LEARNING RESOURCES CENTER
BUILDING 'D' AND 'CR' REMODEL

VENTURA COLLEGE

September 24, 2001
KBZ Job No. 93-18

INSPECTOR COPY

ADDENDUM #9
VENTURA COLLEGE
LEARNING RESOURCES CENTER
BUILDINGS 'D' AND 'CR' REMODEL
 Ventura County Community College District
 SHEET E-302

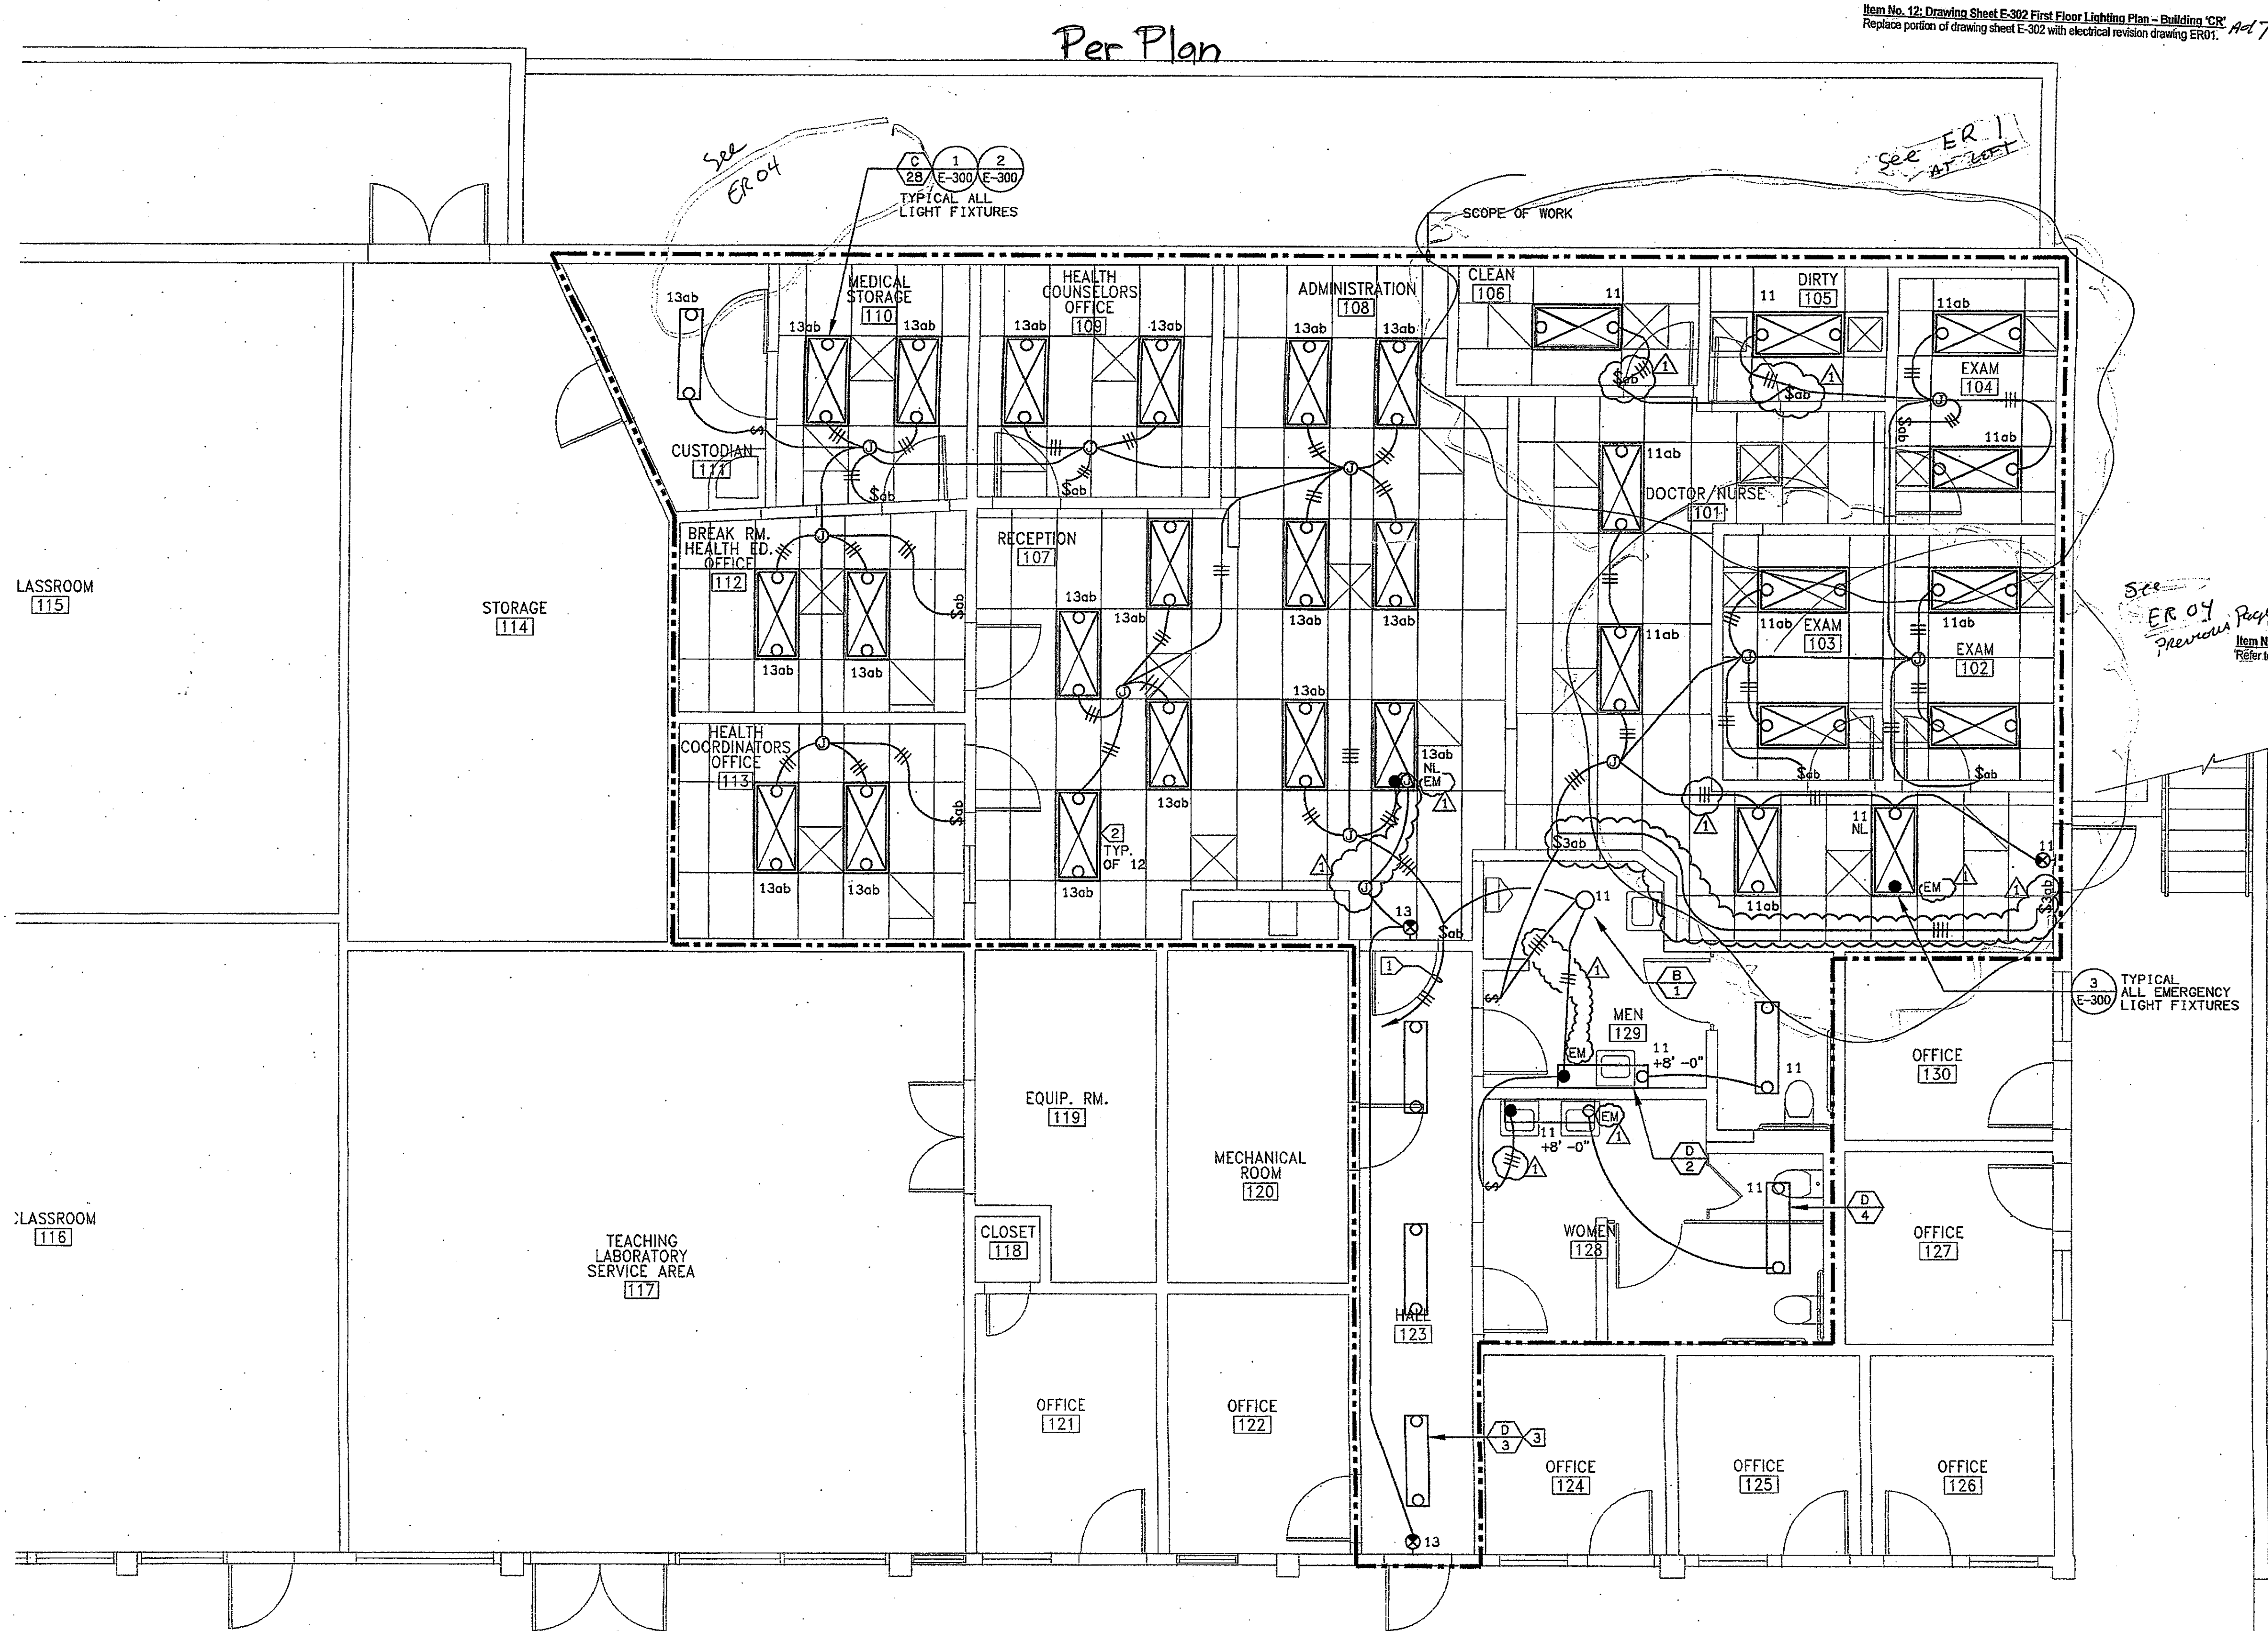
ITEM 8. Drawing Sheet E-302:

- Key note 2 applies to all lights in rooms 107, 108, 109, 112, & 113 and is typical for 16 light fixtures.

ER-05
SHEET E-401

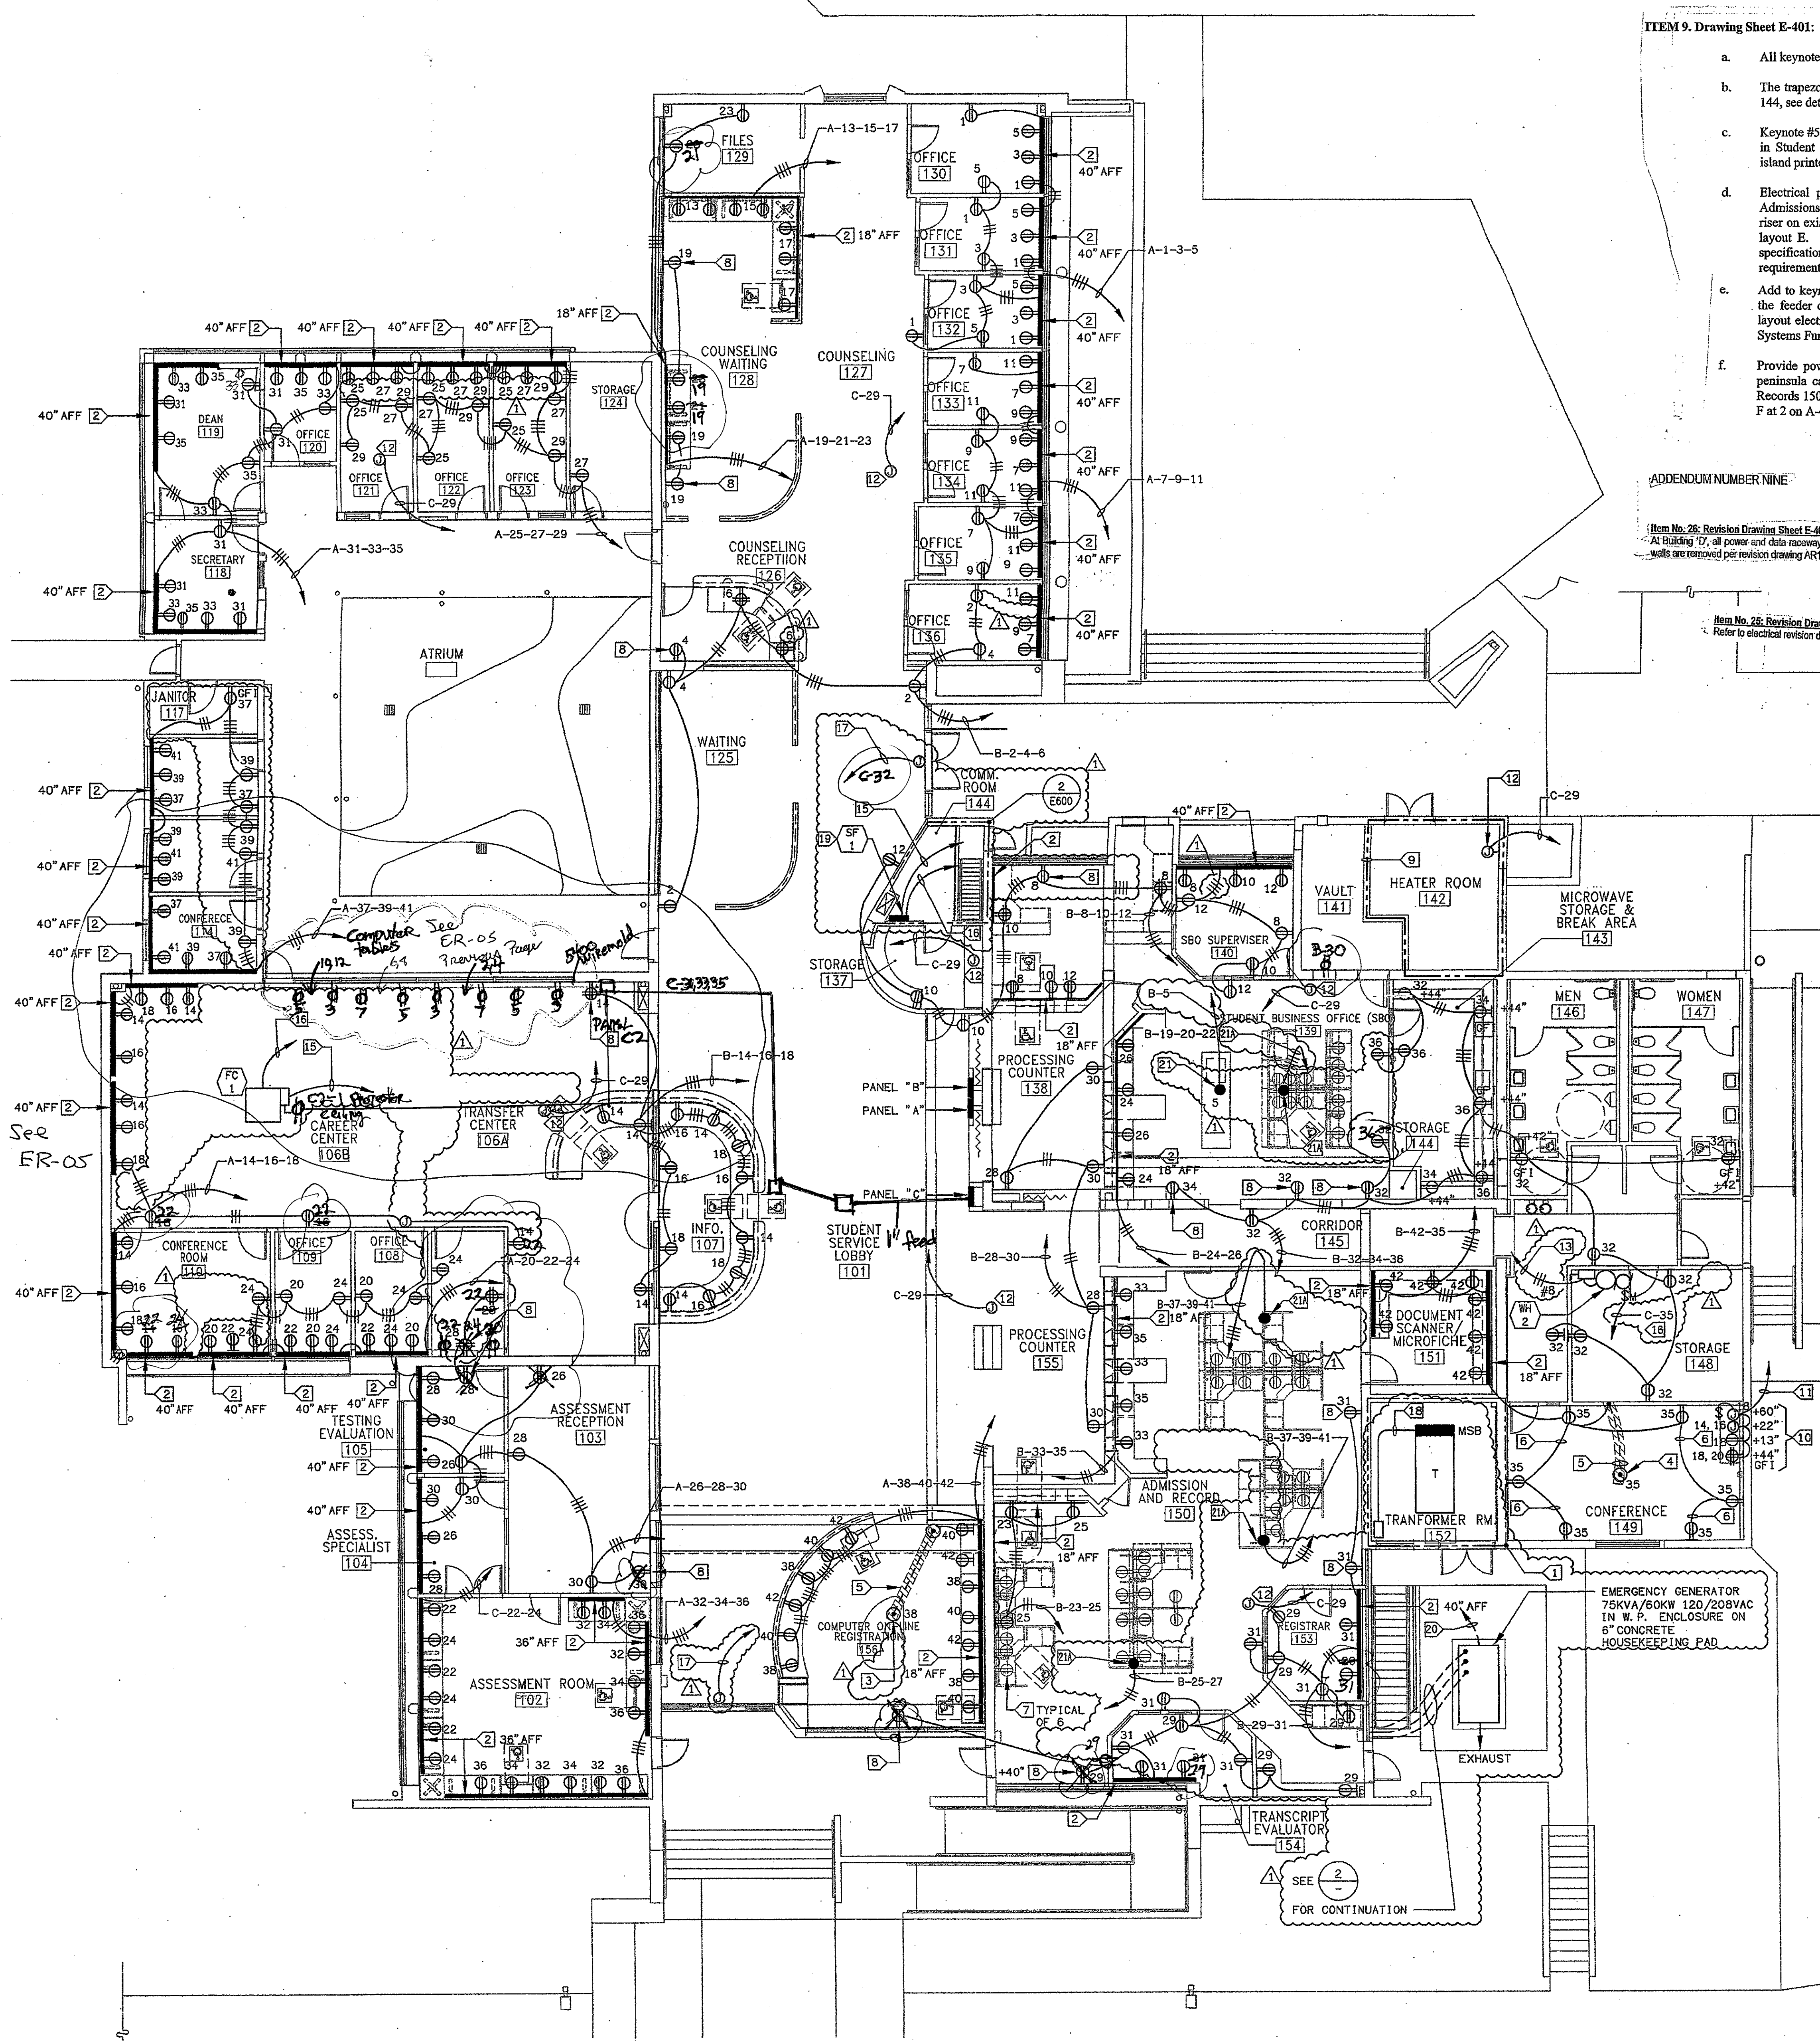
ITEM 9. Drawing Sheet E-401: -ADDENDUM -2-

- All keynote 2 raceways shall be mounted at 36" above finished floor.
- The trapezoidal shaped room north of storage room 137 is Comm. Room 144, see detail 2, Sheet E-600 for room 144 power requirements.

Item No. 26: Revision Drawing Sheet E-401 Ad 9
At Building 'D', all power and data raceways shown at room 102, 106B and 128 to remain as part of Base Bids except where walls are removed per revision drawing ART10, Addendum Number 6.

Item No. 28: Revision Drawing Sheet E-401 Ad 9
Refer to electrical revision drawing ER-05 for modification of portion of First Floor Power Plan at Building 'D'.

ER-06
 SHEET E-402

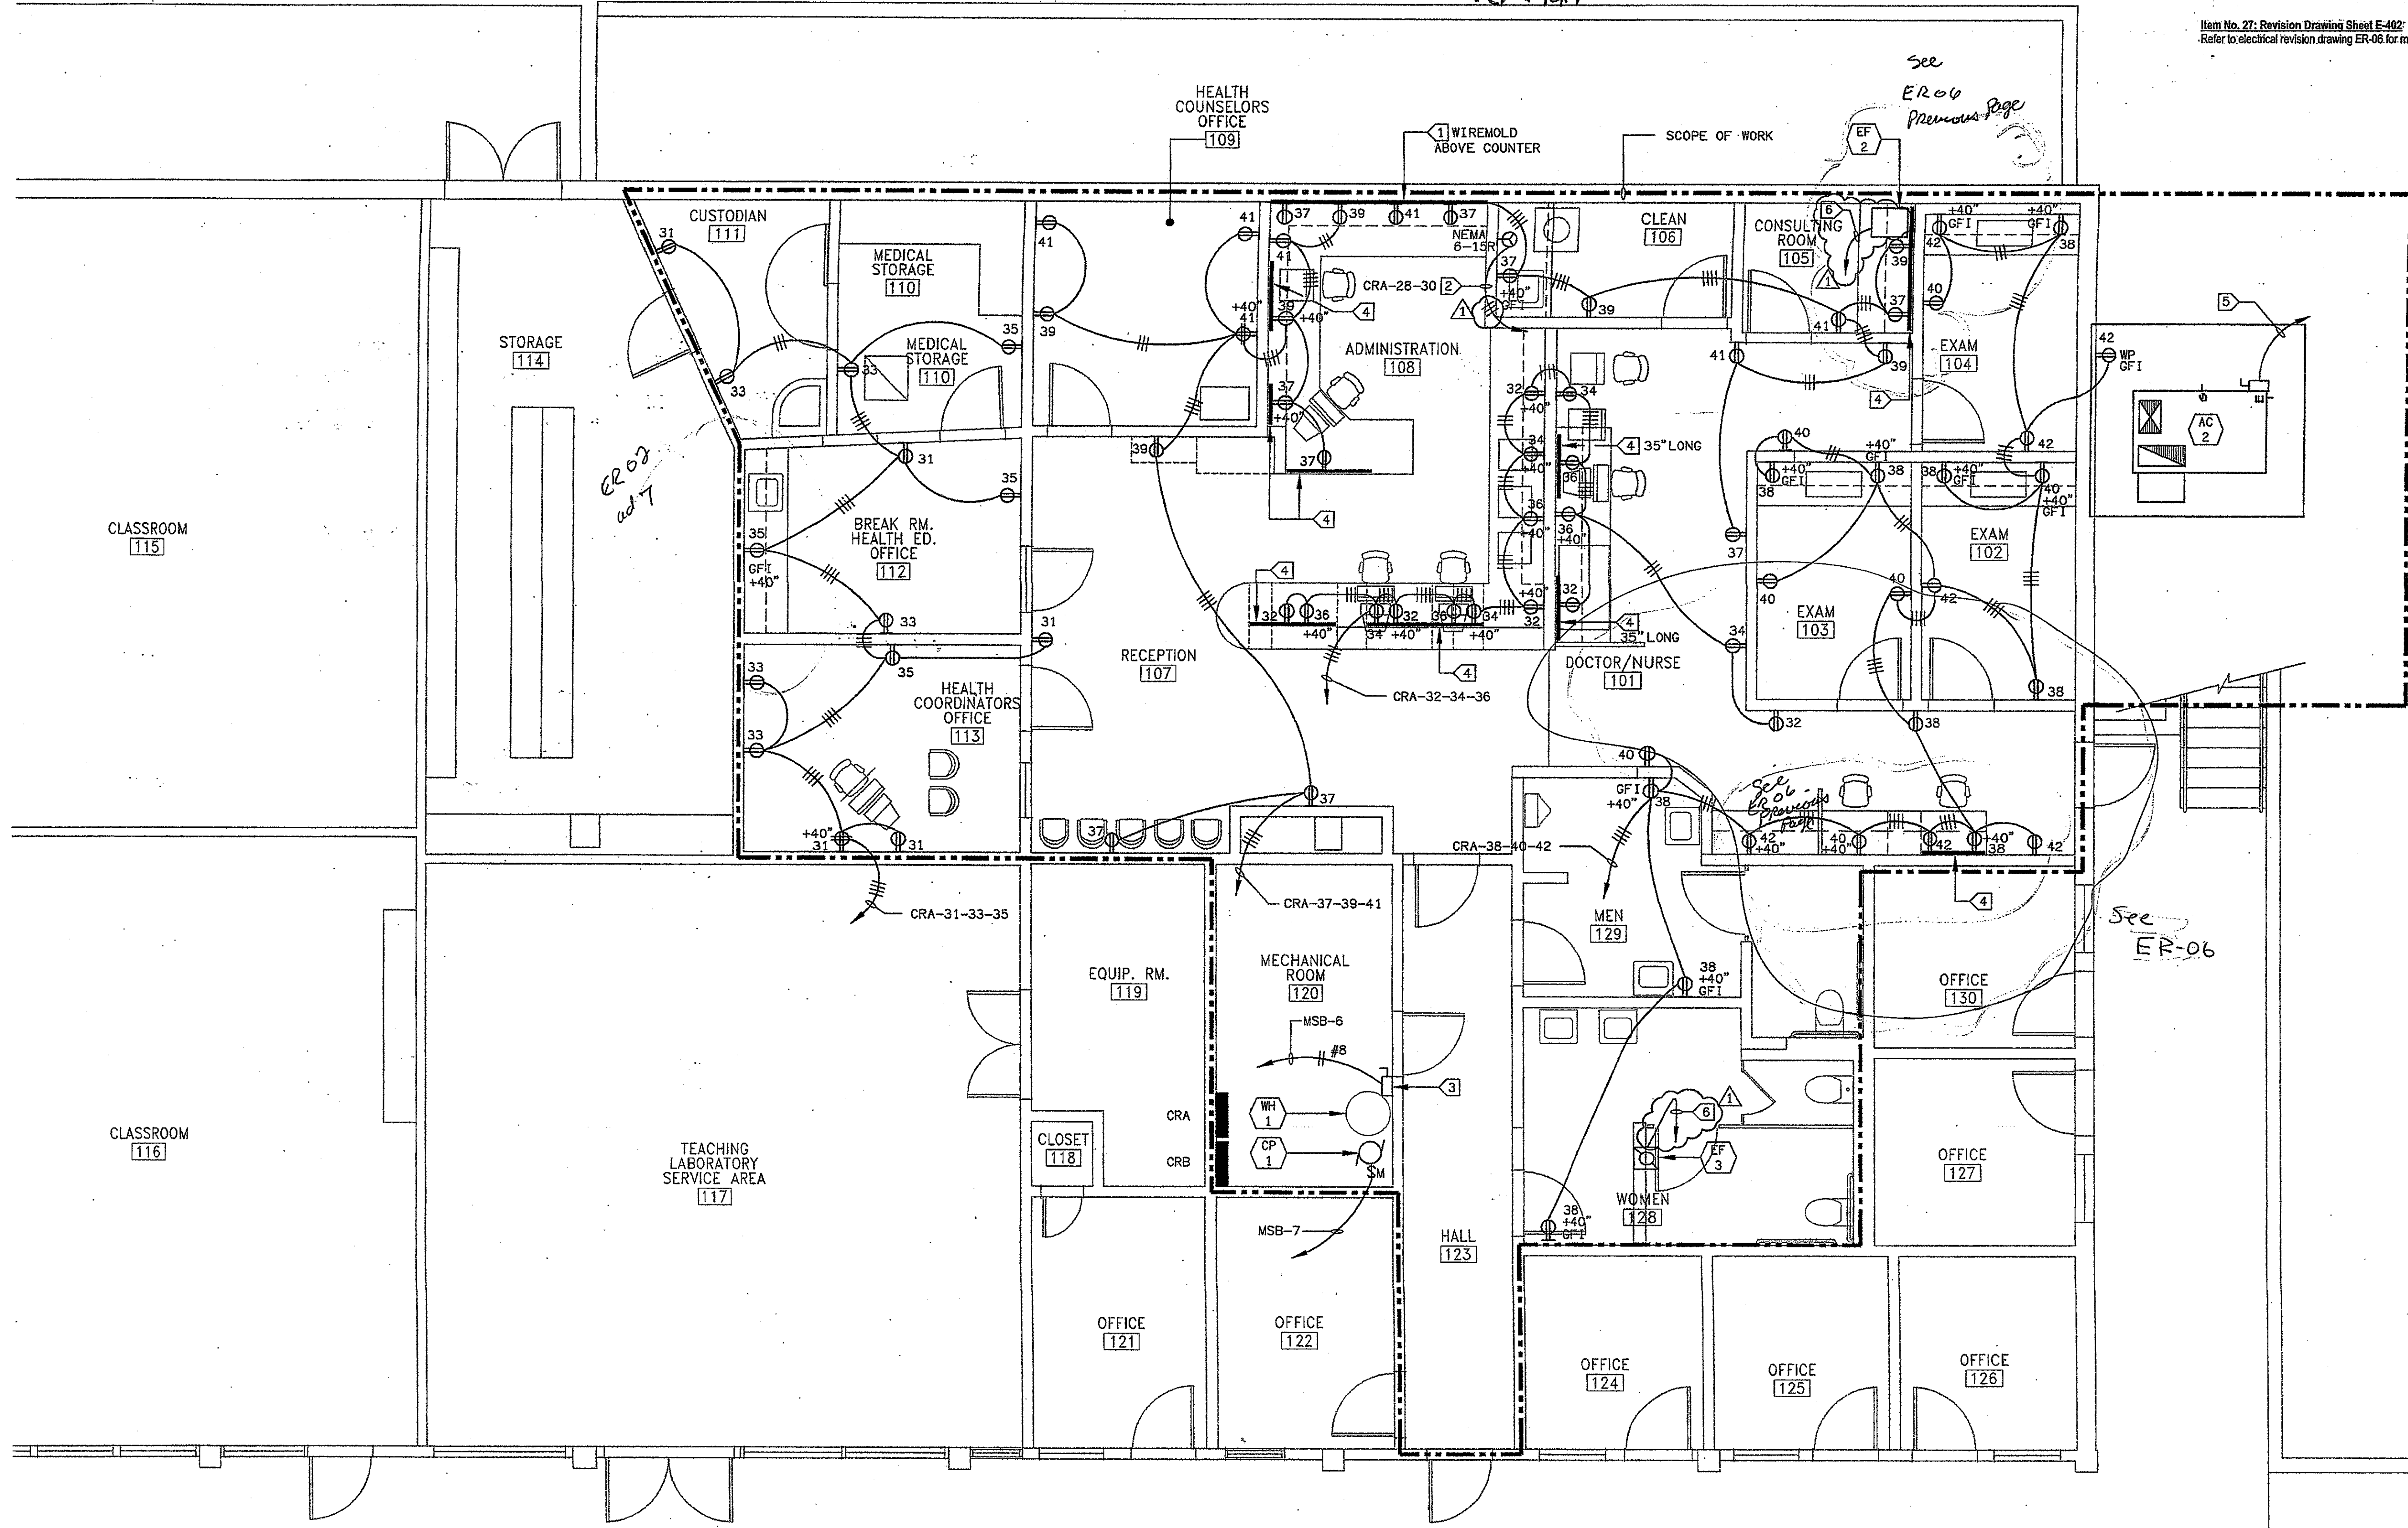
Item No. 13: Drawing Sheet E-402 First Floor Power Plan - Building 'CR' Ad 7
Replace portion of drawing sheet E-402 with electrical revision drawing ER02.

Item No. 27: Revision Drawing Sheet E-402: Ad 9
Refer to electrical revision drawing ER-06 for modification of portion of First Floor Power Plan at Building 'D'.
